COLORADO CENTRE METROPOLITAN DISTRICT ADMINISTRATION BUILDING - SITE DEVELOPMENT PLAN

PCD File No. PPR-21-51

EPC STORMWATER REVIEW COMMENTS
IN ORANGE BOXES WITH BLACK TEXT

COLORADO CENTRE METROPOLITAN DISTRICT
ADMINISTRATIVE BUILDING - SITE DEVELOPMENT PLAN
GRADING & EROSION CONTROL PLAN

COLORADO CENTRE METROPOLITAN DISTRICT
ADMINISTRATIVE BUILDING – SITE DEVELOPMENT PLAN
EXISTING SITE PLAN

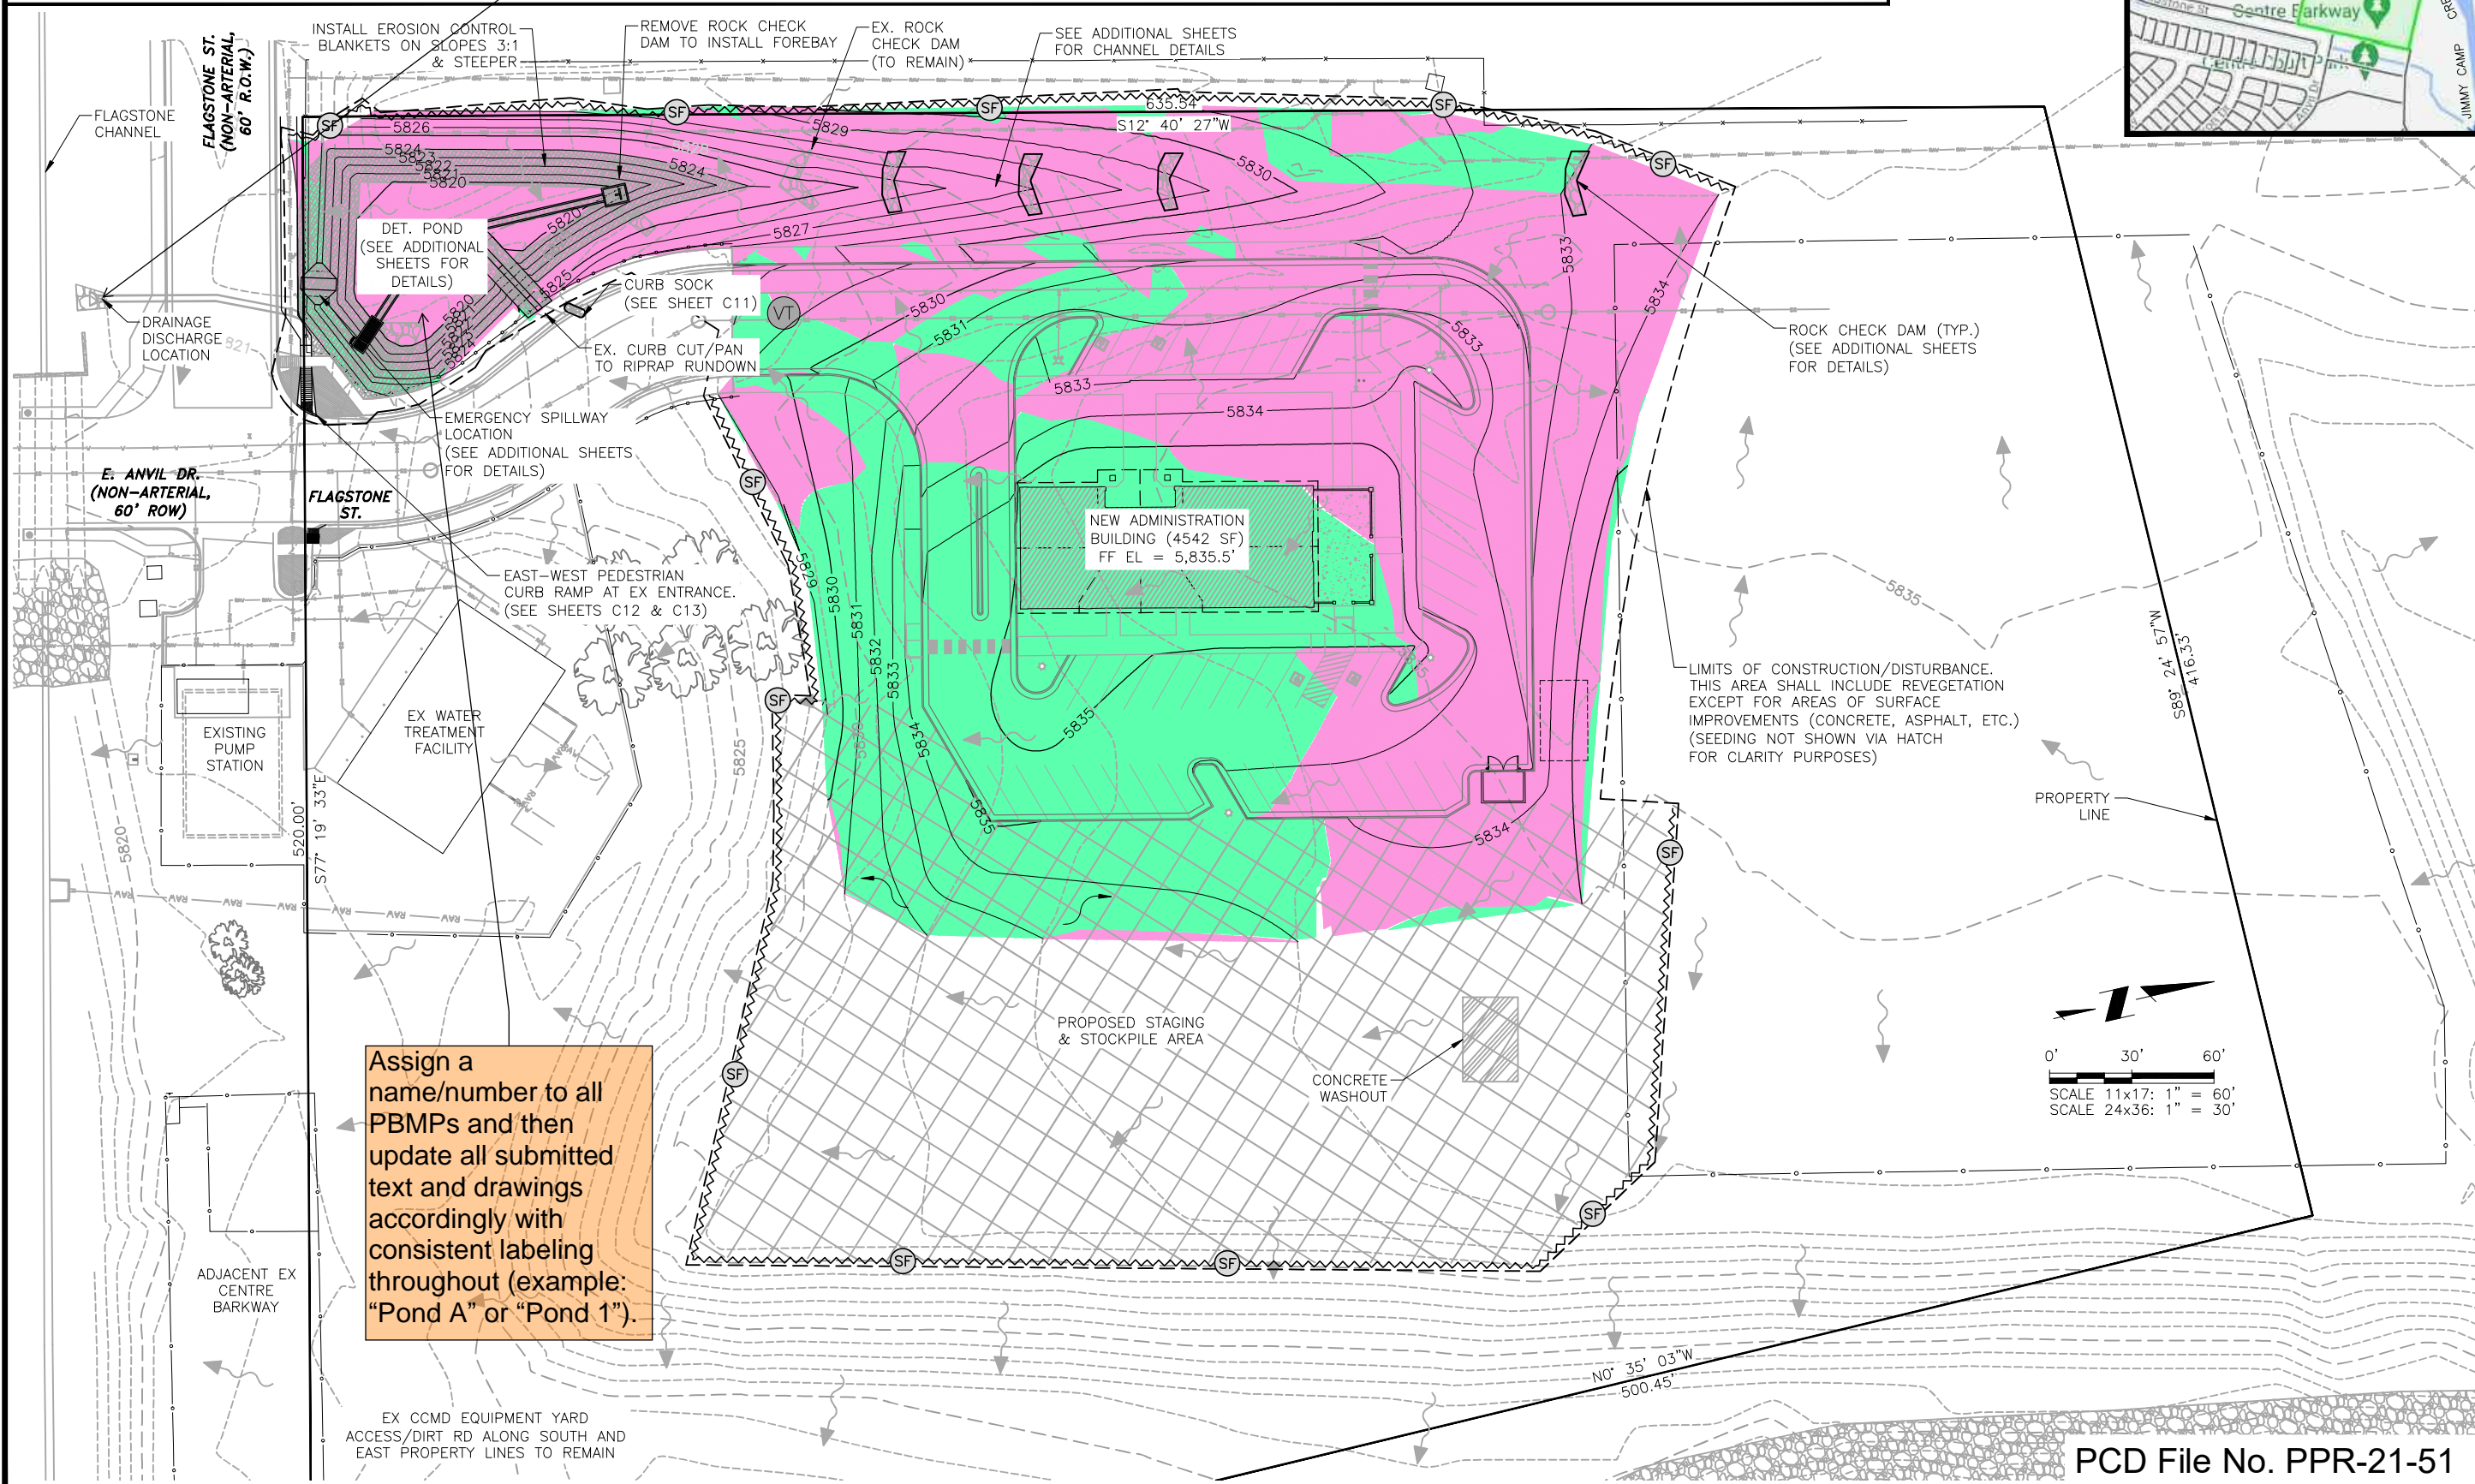
note that this outlet protection riprap needs to be removed and re-established as discussed in the DR_v3 comments. unresolved.

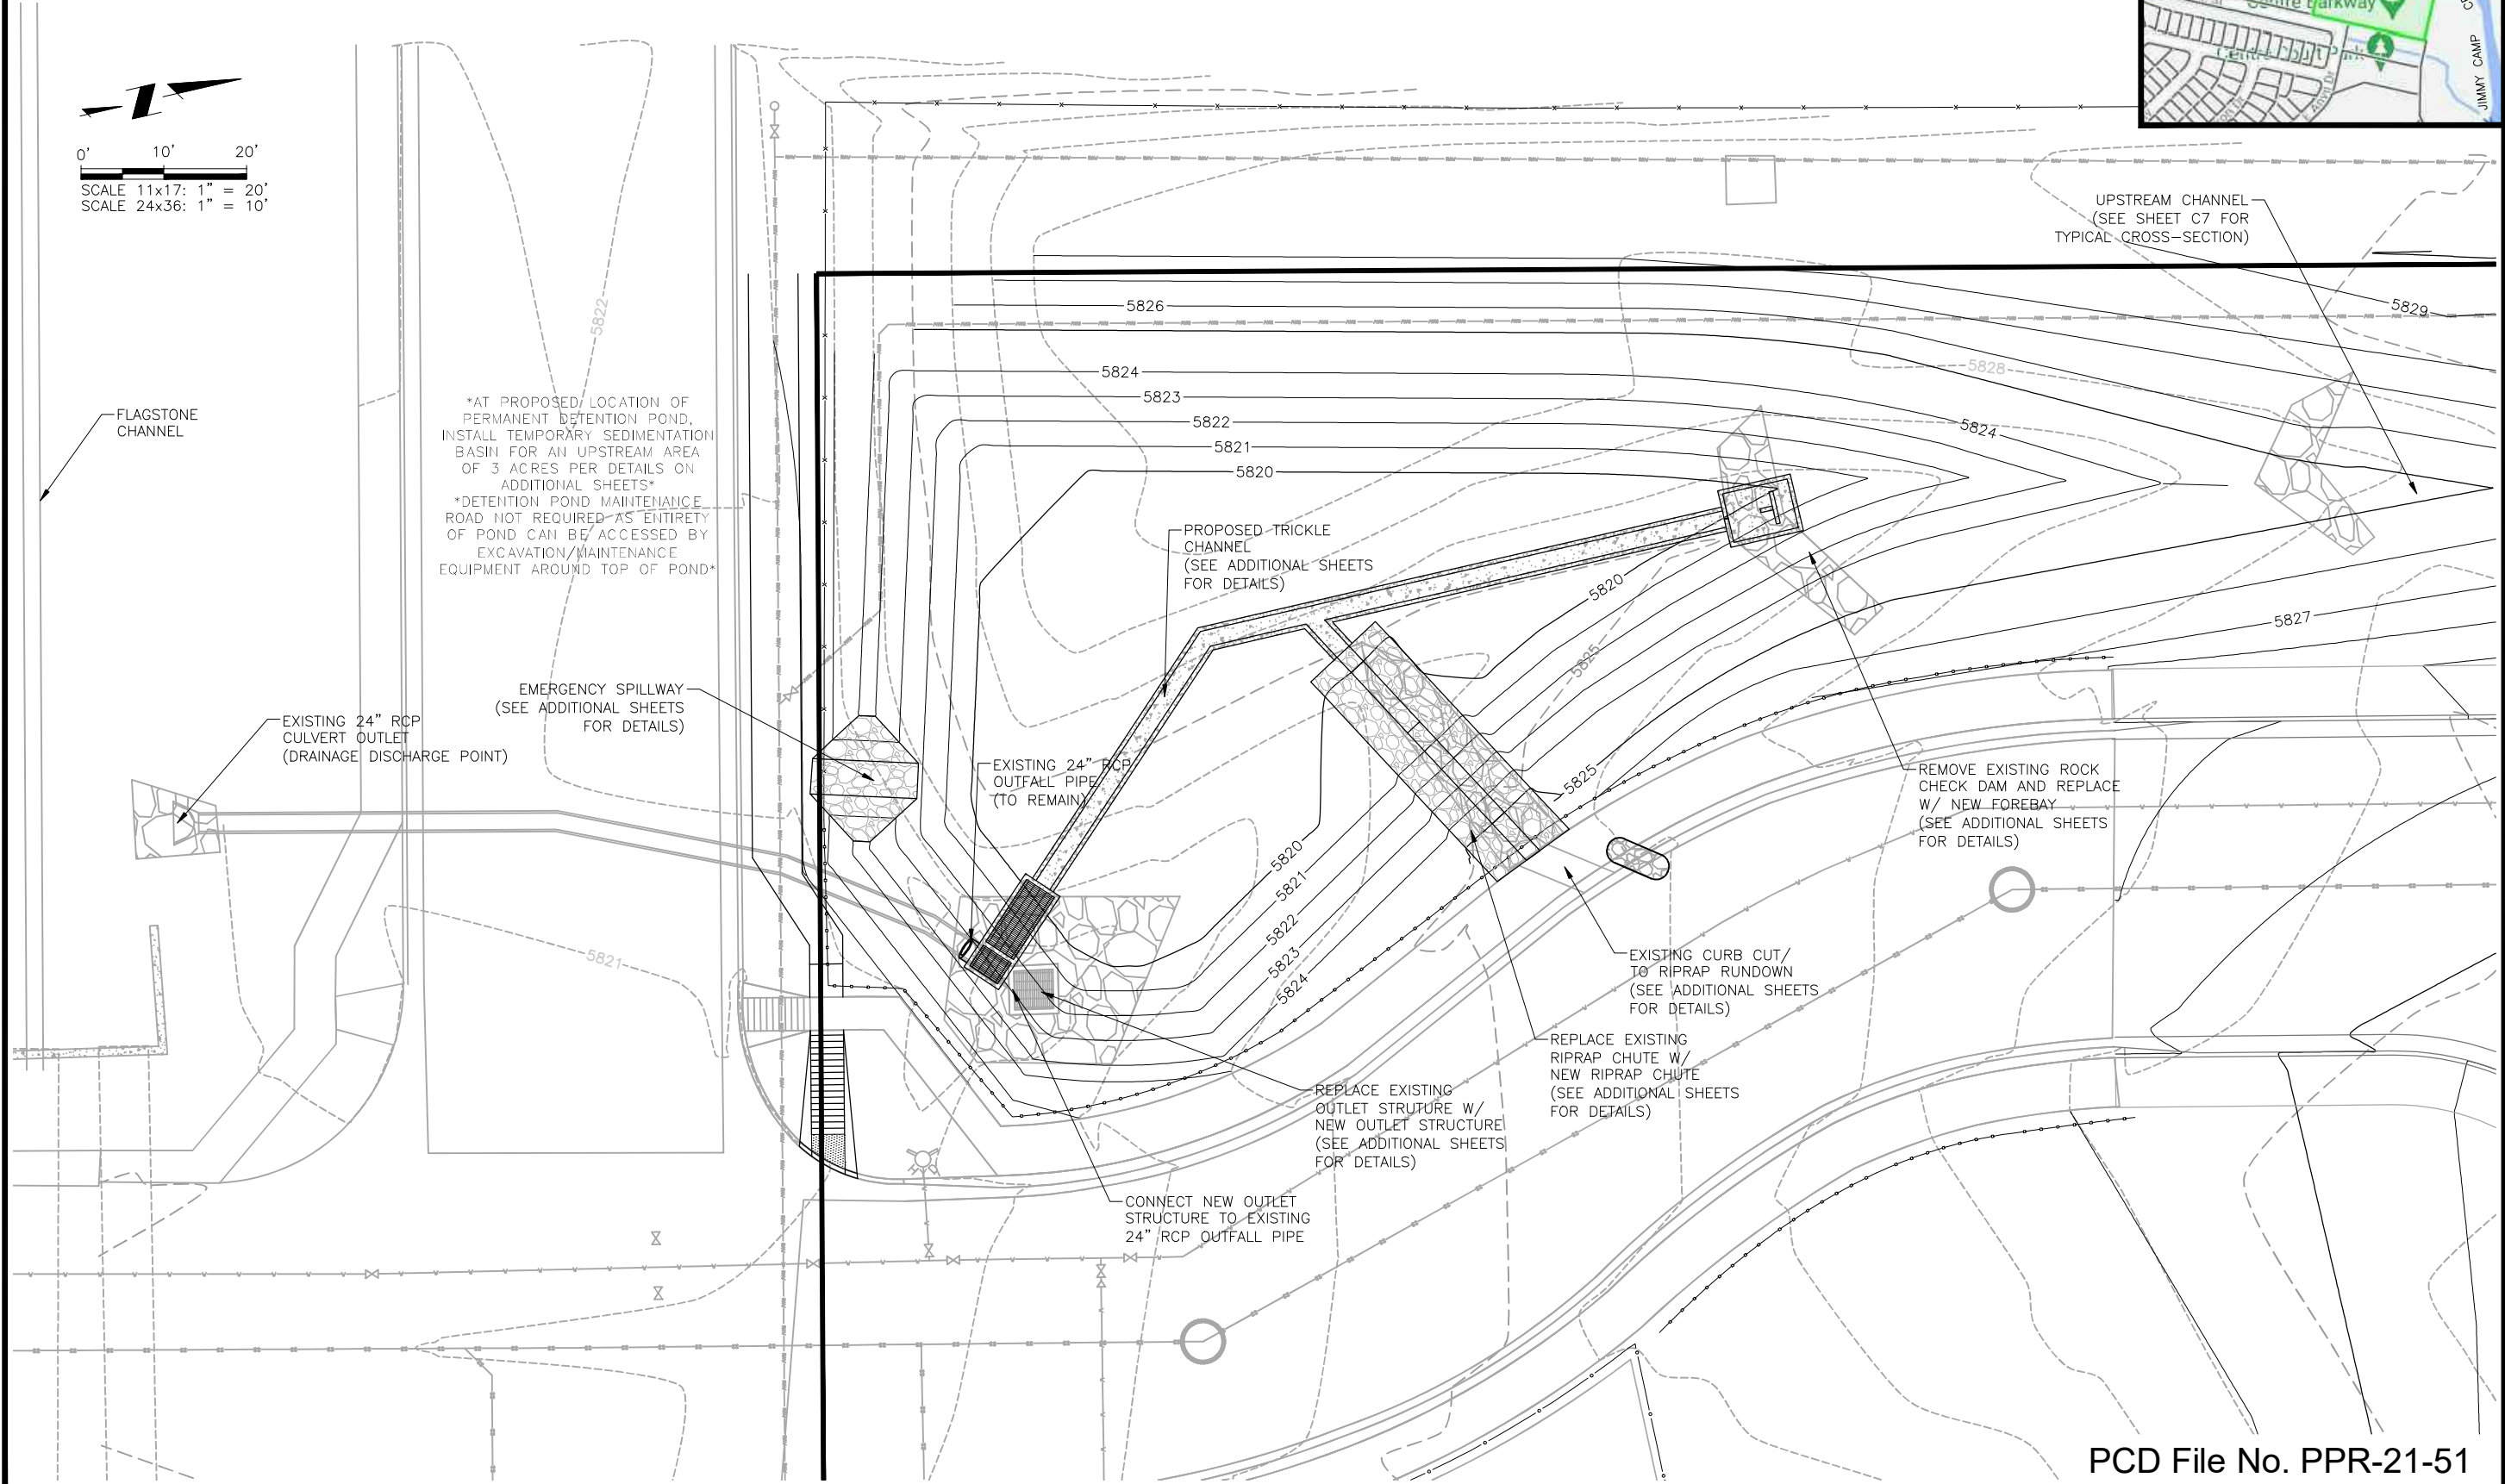
call out as "Initial/Interim" and use proposed contour lines since it is not existing.

Assign a name/number to all PBMPs and then update all submitted text and drawings accordingly with consistent labeling throughout (example: "Pond A" or "Pond 1").

COLORADO CENTRE METROPOLITAN DISTRICT
ADMINISTRATIVE BUILDING - SITE DEVELOPMENT PLAN
 DETENTION POND PLAN

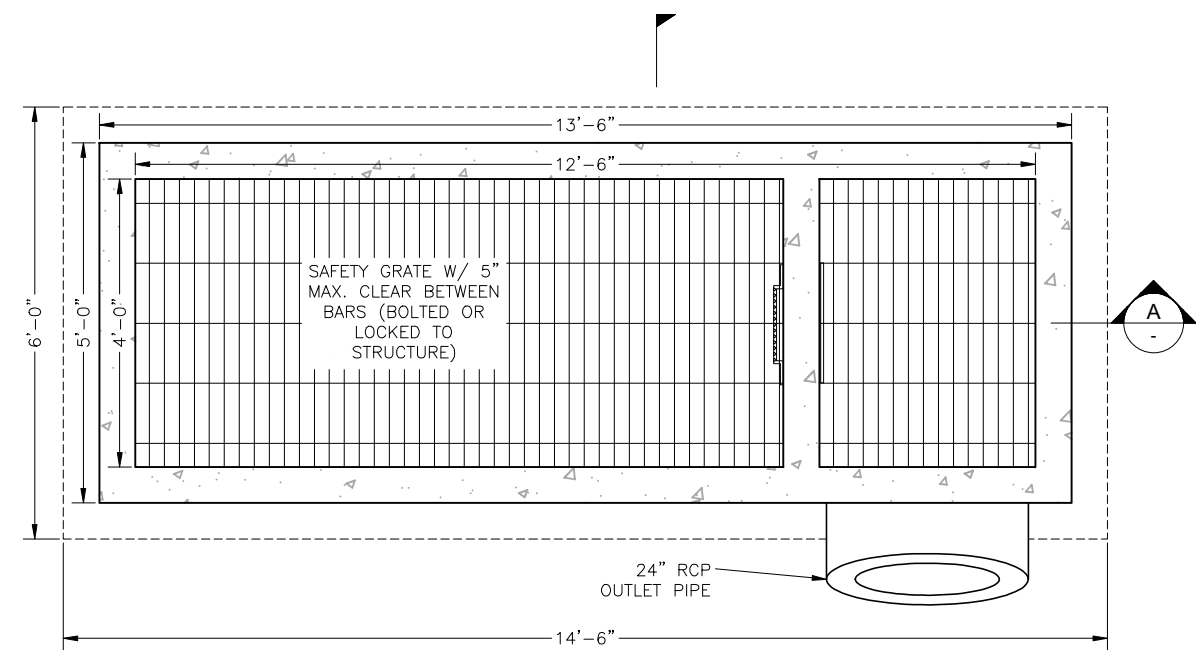
comments were generated based on newly provided pond details

OUTLET STRUCTURE - TOP VIEW
11x17 SCALE: 3/8"=1'-0"
24x36 SCALE: 3/4"=1'-0"

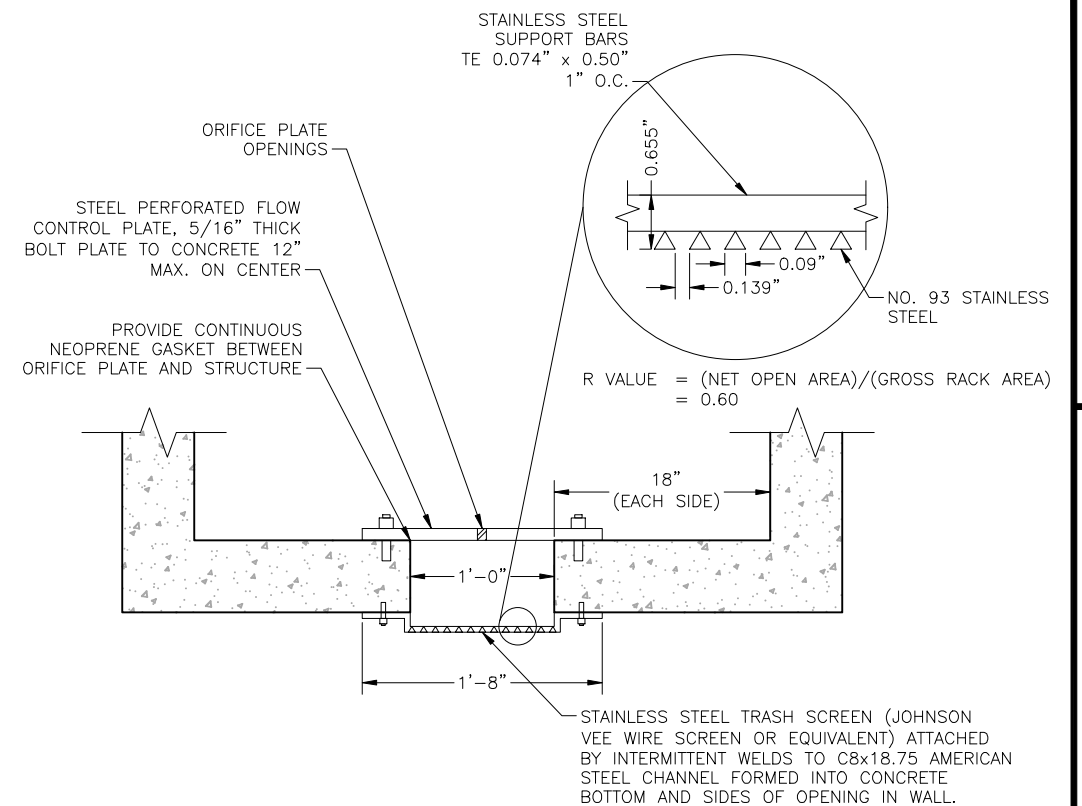
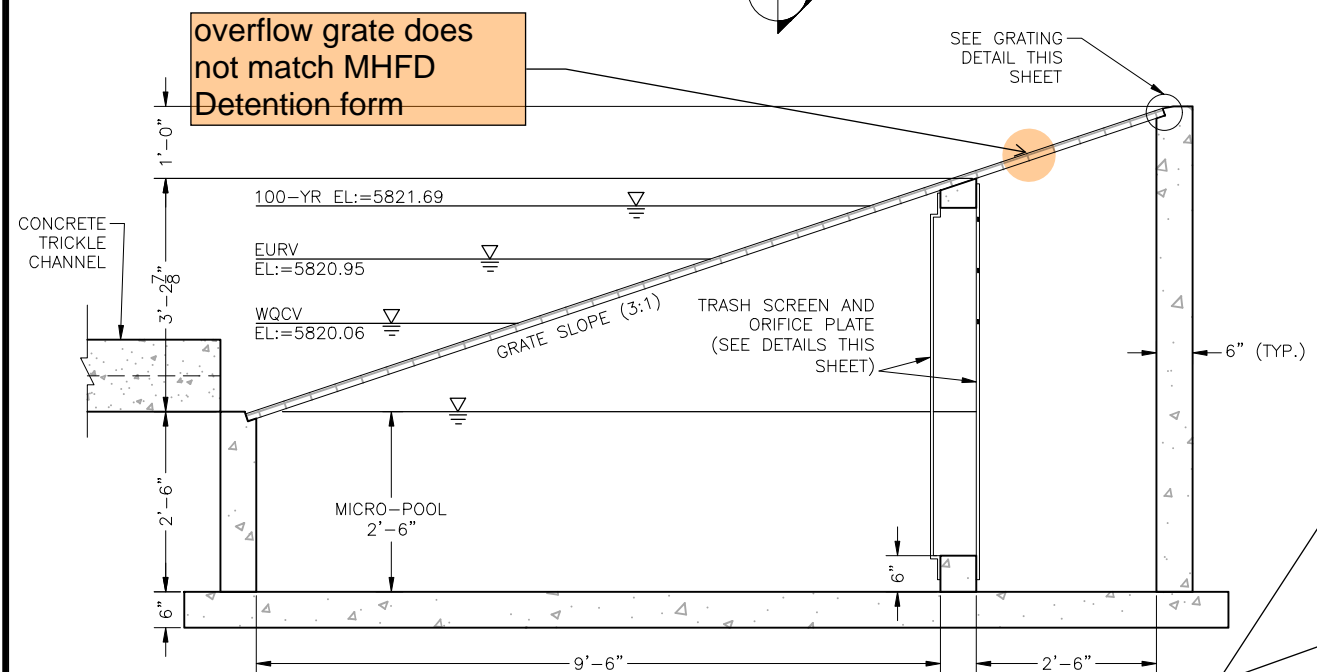
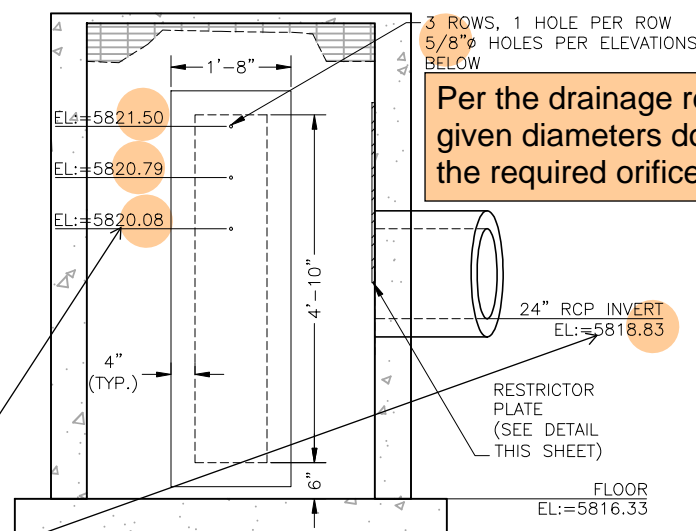
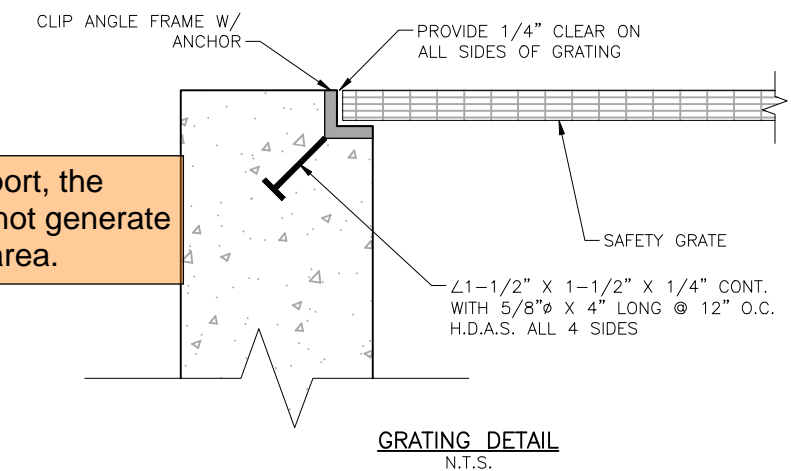
elevations do not match the MHFD Detention form
